RE: Site Plan: CLANCY STREET FOOD COURT , Log Number: 22SP0058 **Revised Submission**

**RE: Clancy Street Food Court**  
**s/e/c LIE service road and County Road 111**  
**Manorville, NY 11949**  
**SCTM No. 0200 46200 0200 005001**  
**Log Number: 22SP0058**

The following is in response to the Town's comments in regard to the aforementioned site plan.

**SCDPW SIGNAGE**

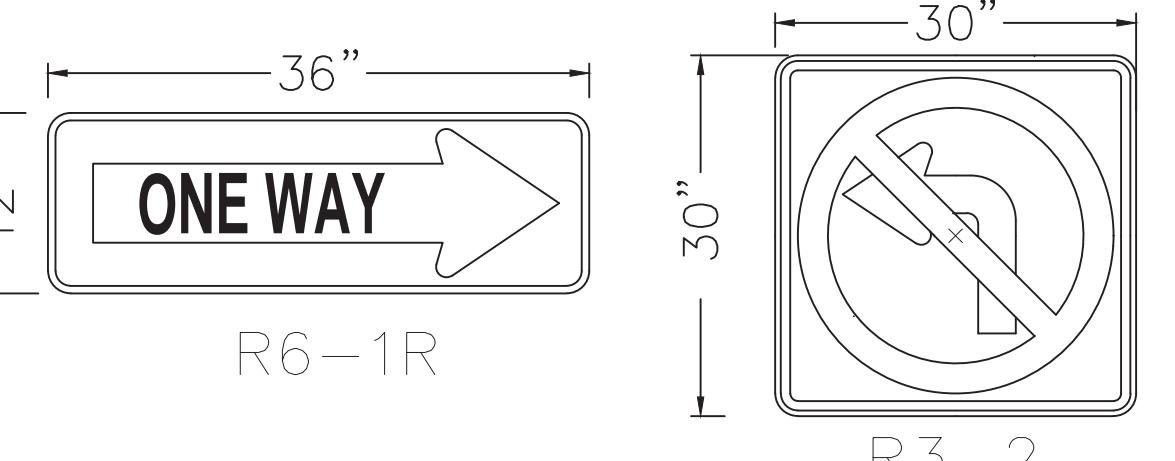
Add proposed signage for “One Way”, “Stop”, “No Left Turn” and “Keep Right”.

# NYSDOT DETAIL

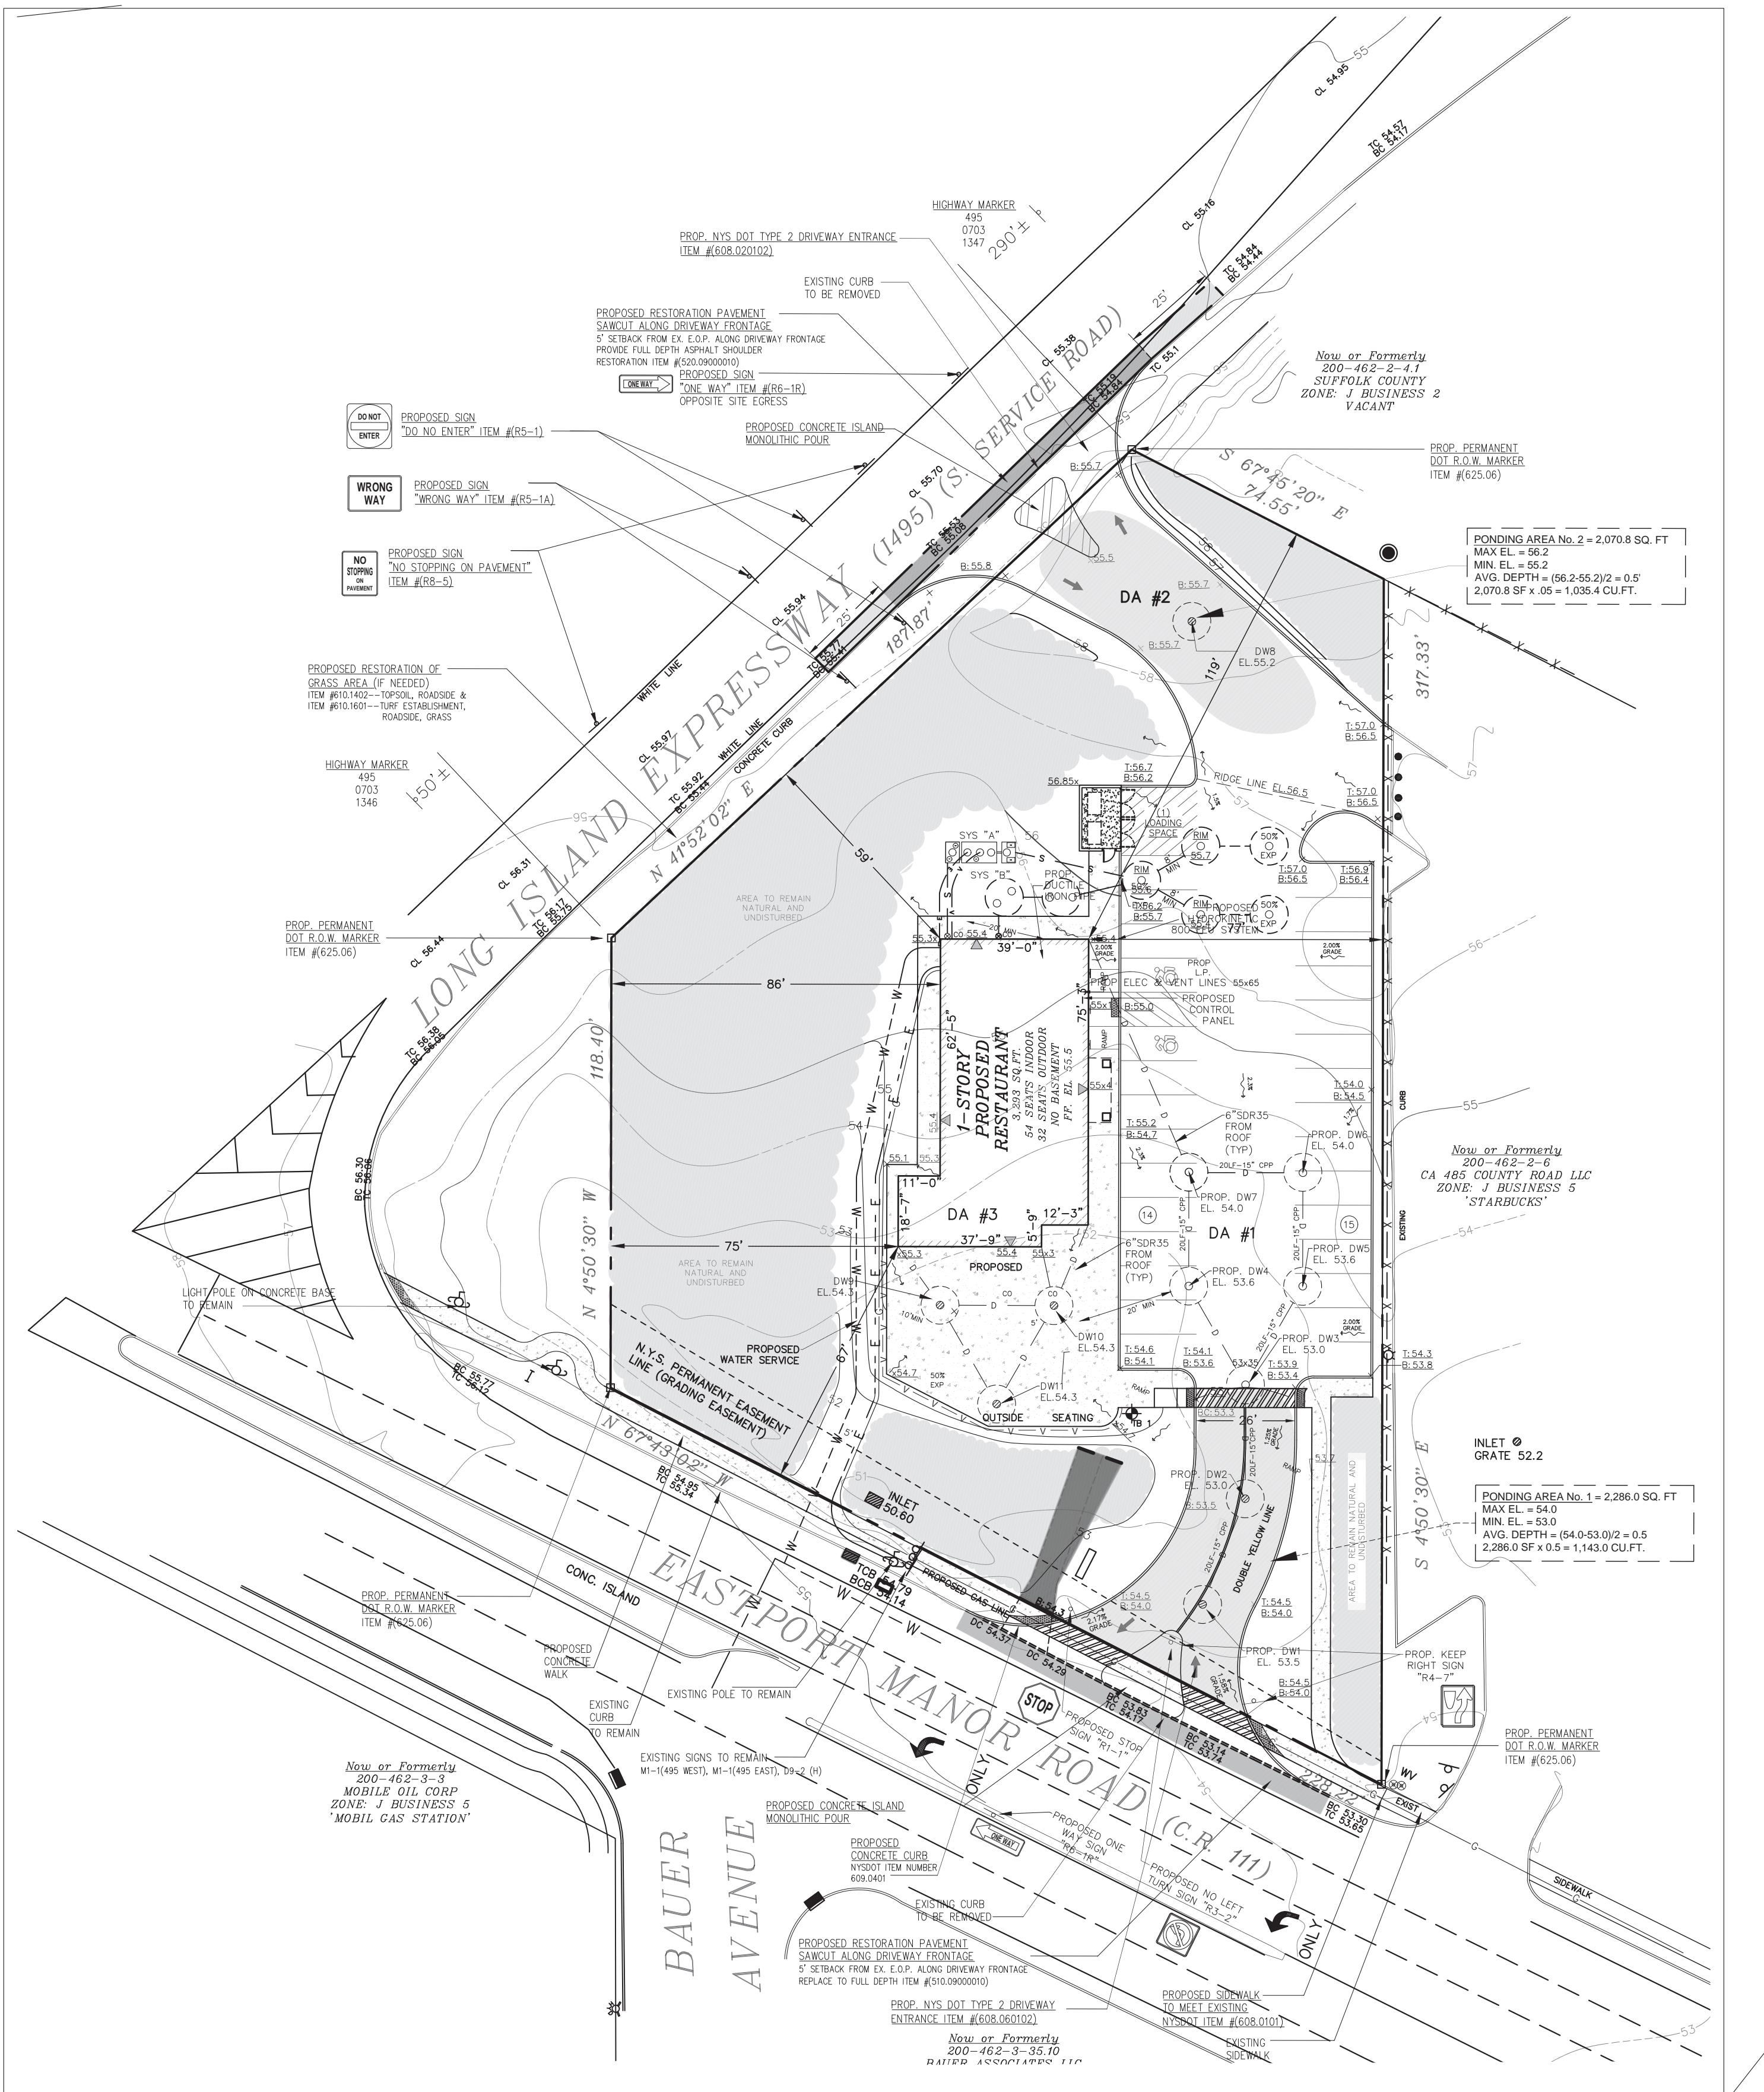
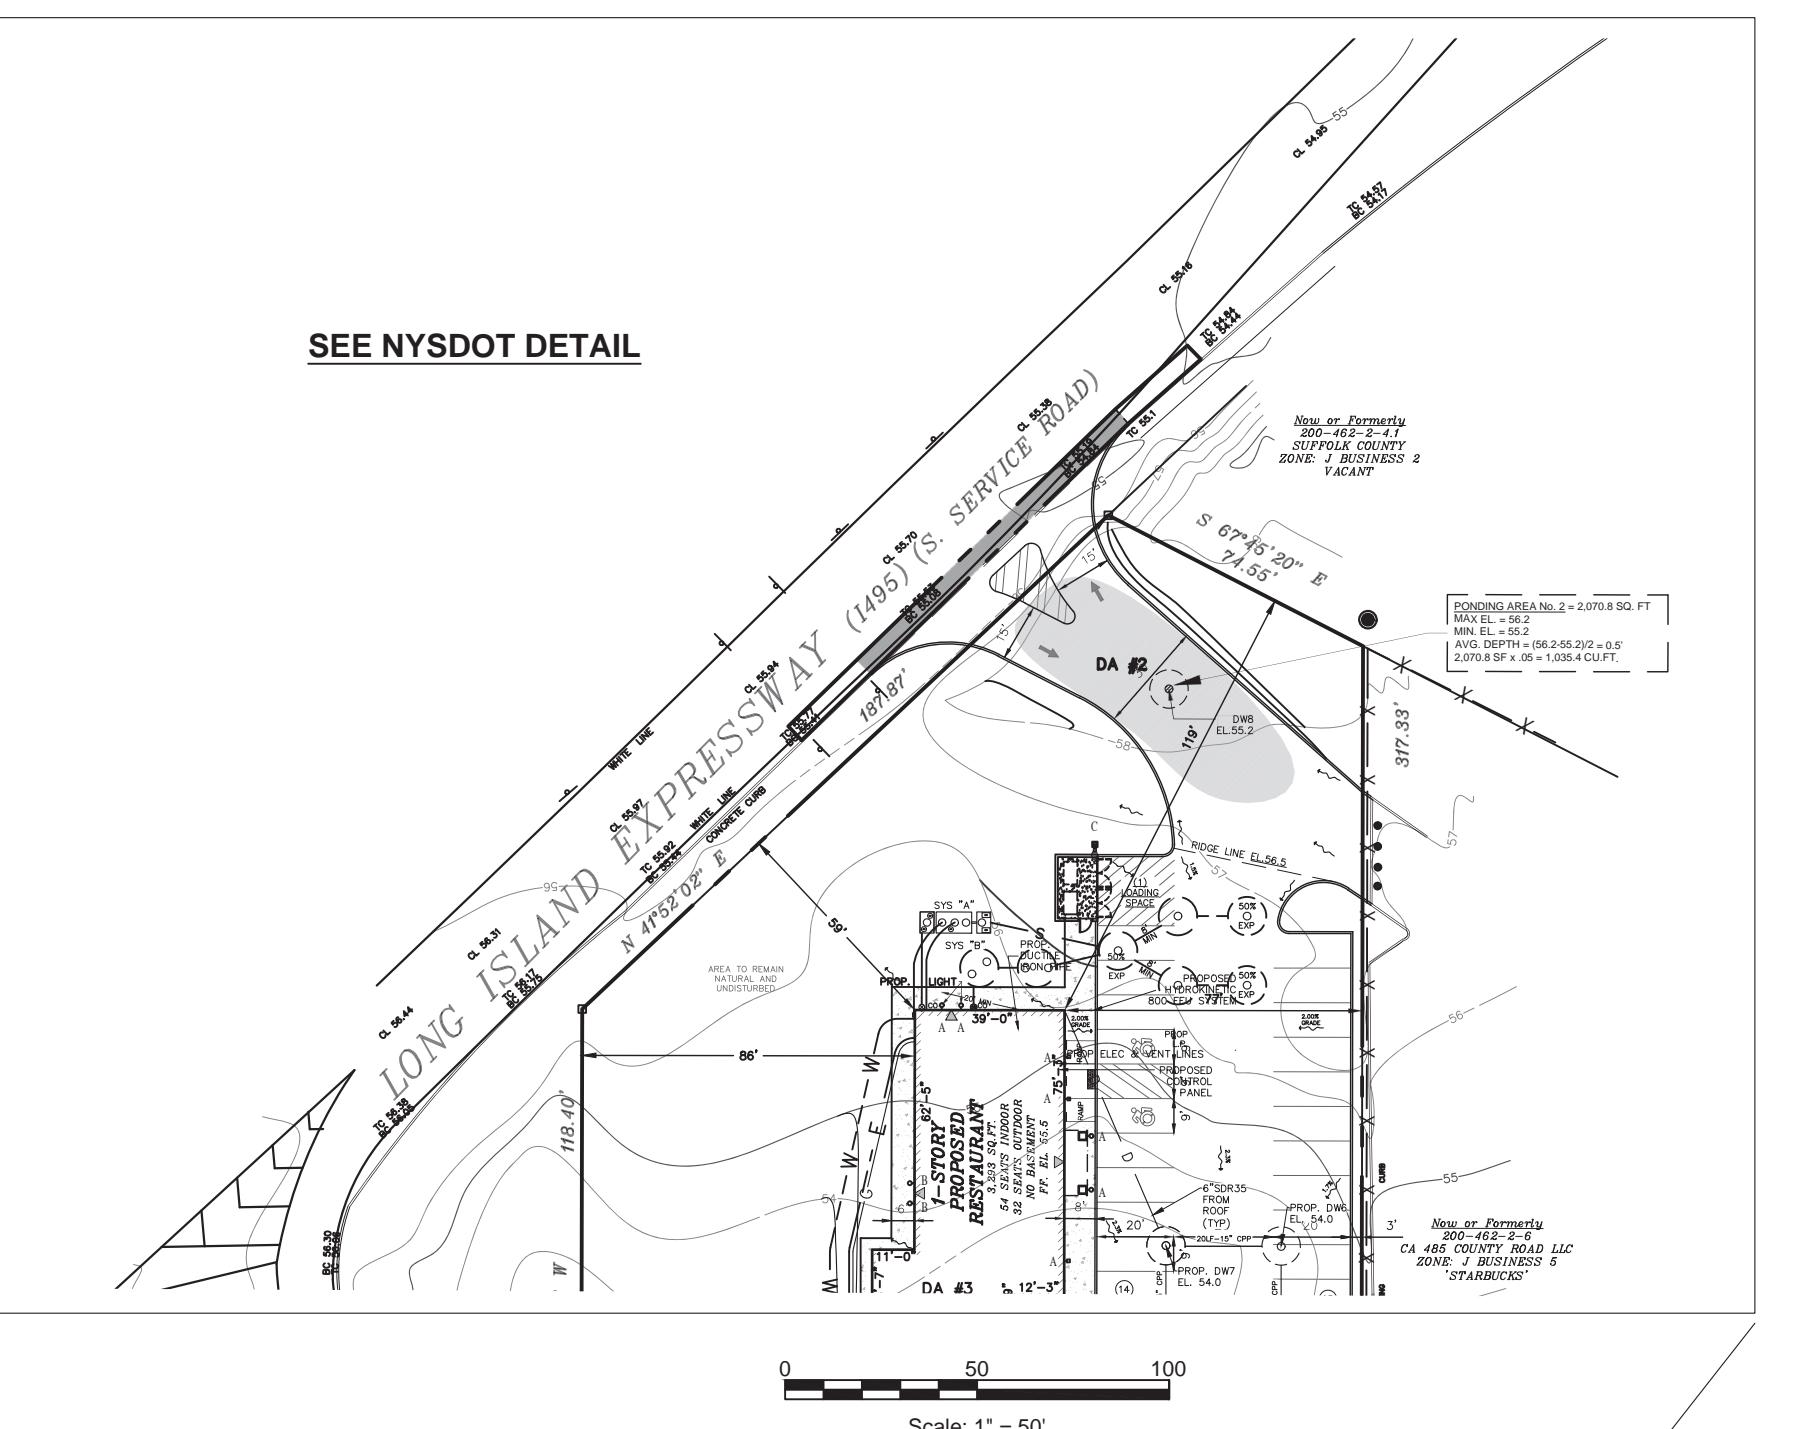
Add specifications for Full depth asphalt pavement, 35' curb radii, monolithic concrete directional island and pedestrian ramps.

Add proposed concrete sidewalk for entire frontage along CR 111.
